CO 119 Bikeway

Concept Design Validation Memo

November 4, 2021

Concept Plan Mark-Up

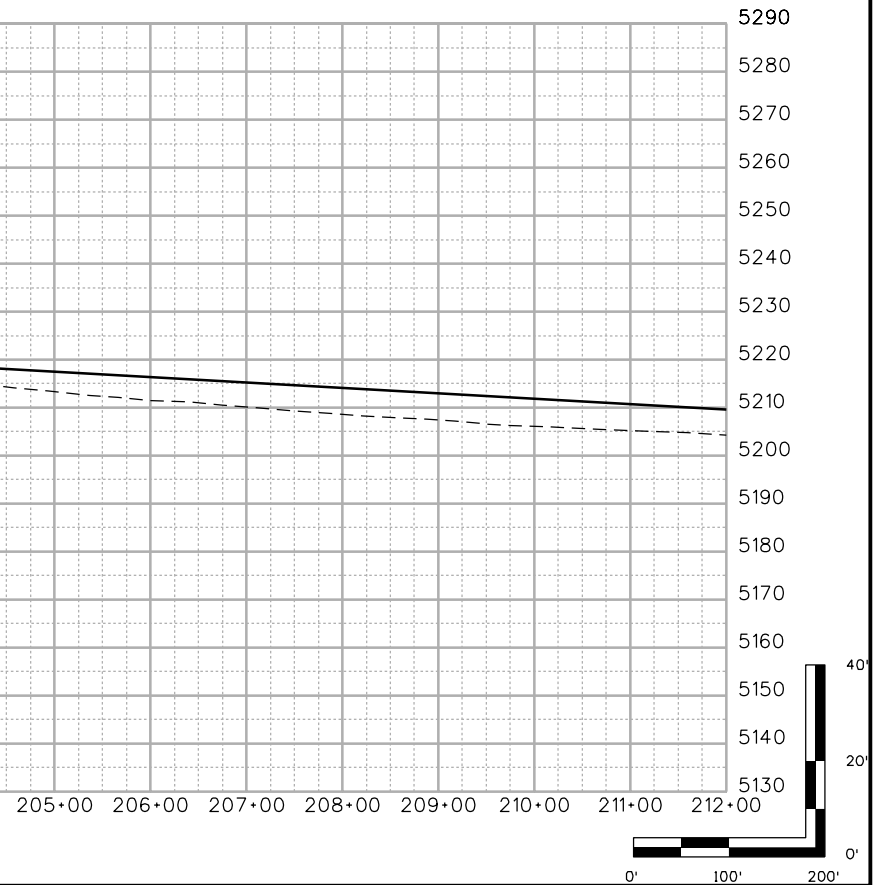
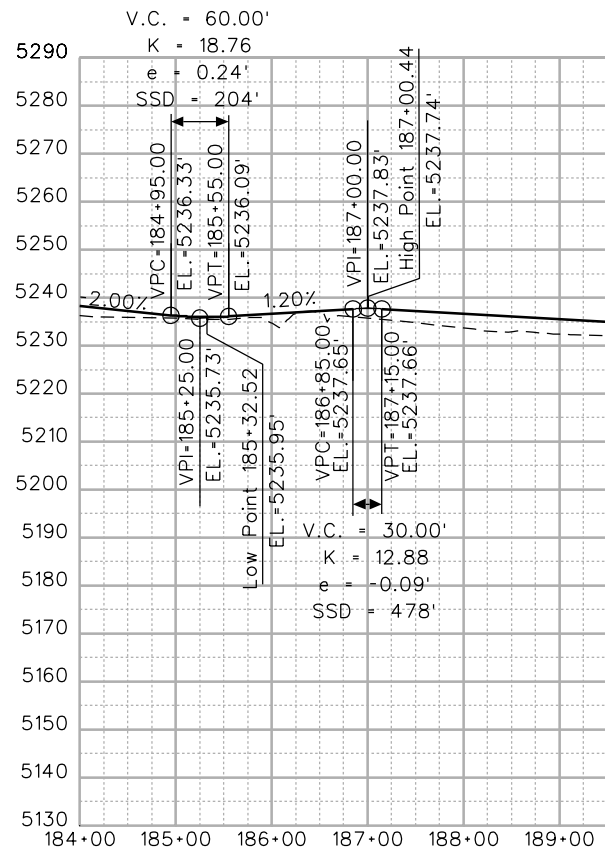
ALIGNMENT GOOD AS-IS. TERRAIN IS FLAT AND WIDE OPEN WITH NO TREES OR WETLANDS

As Constructed		PLAN AND PROFILE			Project No./Code
No Revisions:					STA 1191-035
Revised:		Designer:	KRC	Structure Numbers	22455
Void:		Detailer:	REW		
		Sheet Subset:	P&P	Subset Sheets:	11 of 18
					Sheet Number

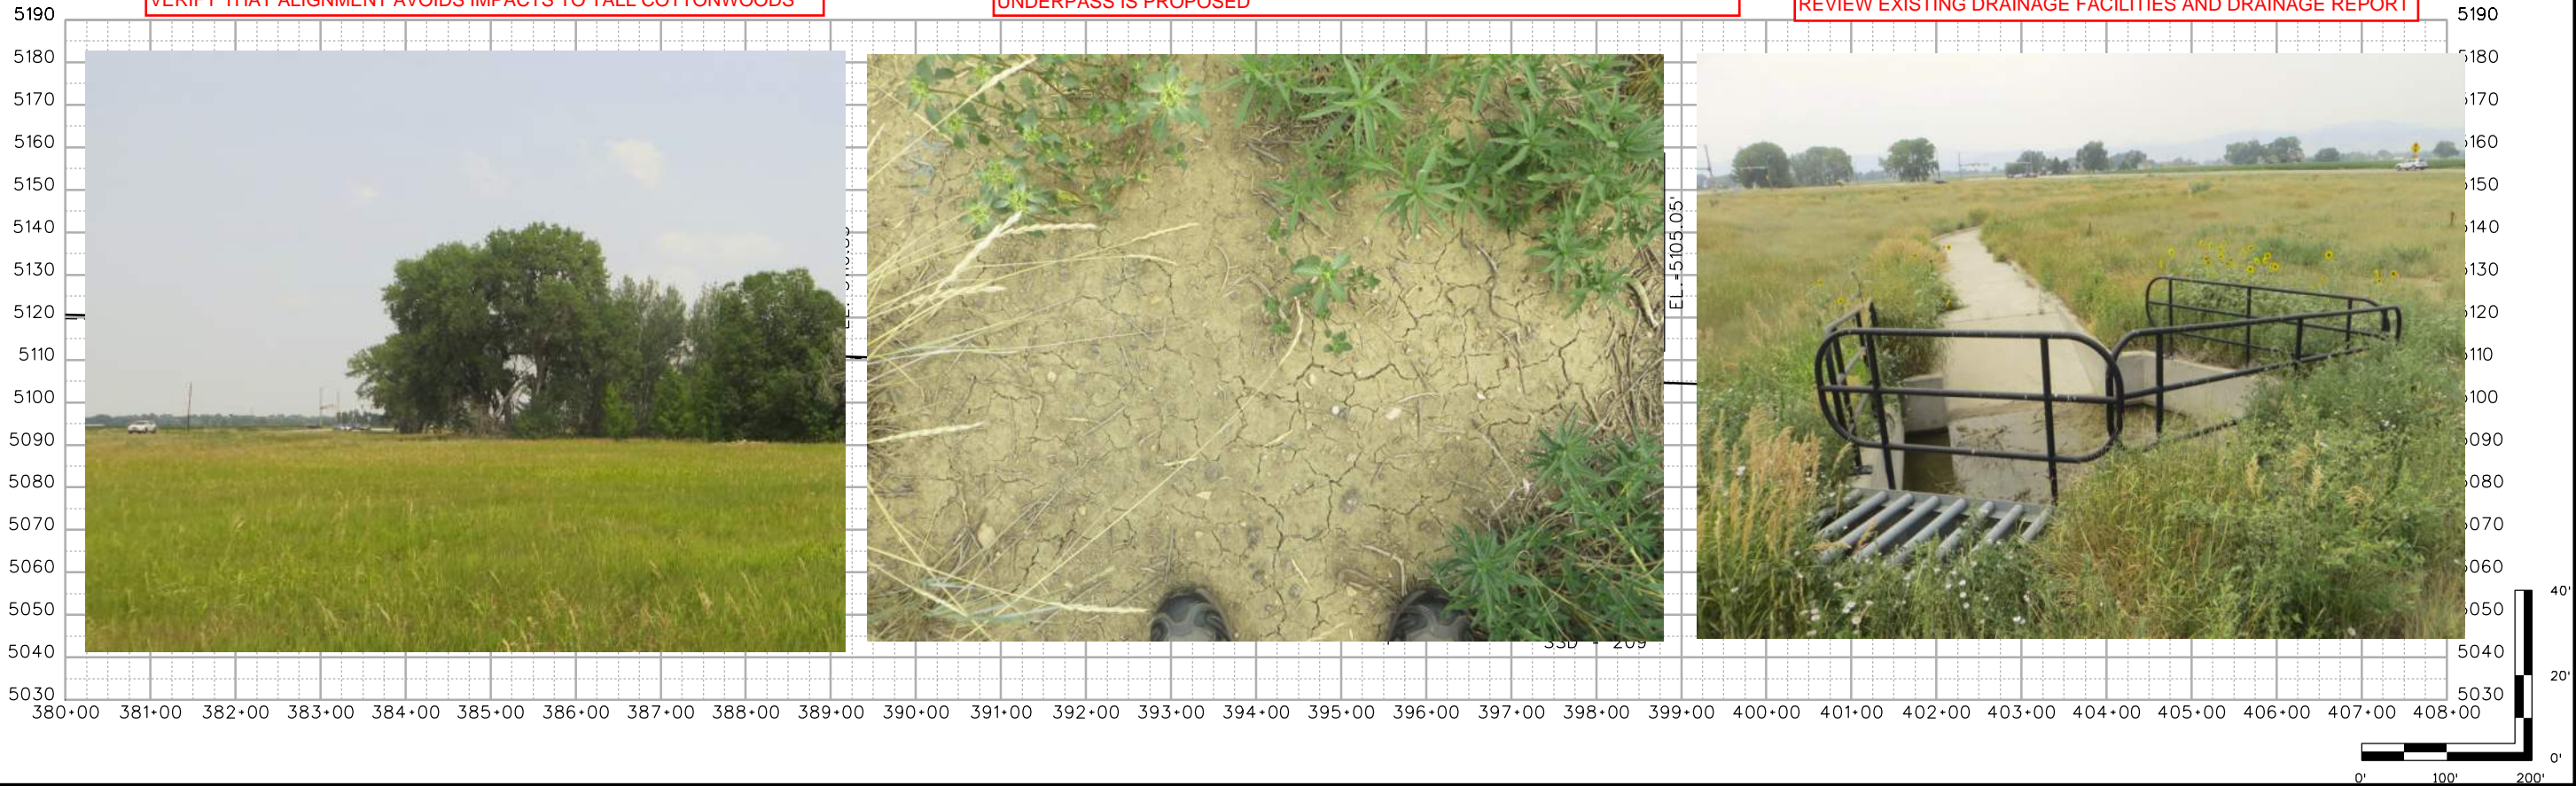
INCREASE SKEW OF UNDERPASS TO IMPROVE SIGHT LINES AT BOTH SIDES OF THE UNDERPASS. THIS WILL BE ESPECIALLY IMPORTANT AT THE NORTH APPROACH WITH THE CONFINING RETAINING WALLS. LAY BACK WALLS AS MUCH AS POSSIBLE

BIKEWAY ALIGNMENT TO BE COORDINATED WITH SAFETY AND MOBILITY PROJECT. PROVIDE CONNECTIONS TO BOTH SIDES OF NIWOT ROAD. UNDERPASS DRAINAGE A SIGNIFICANT CONCERN

SOIL AND VEGETATION SHOWS SIGNS OF STANDING WATER WHERE THE UNDERPASS IS PROPOSED

REVIEW EXISTING DRAINAGE FACILITIES AND DRAINAGE REPORT

VERIFY THAT ALIGNMENT AVOIDS IMPACTS TO TALL COTTONWOODS
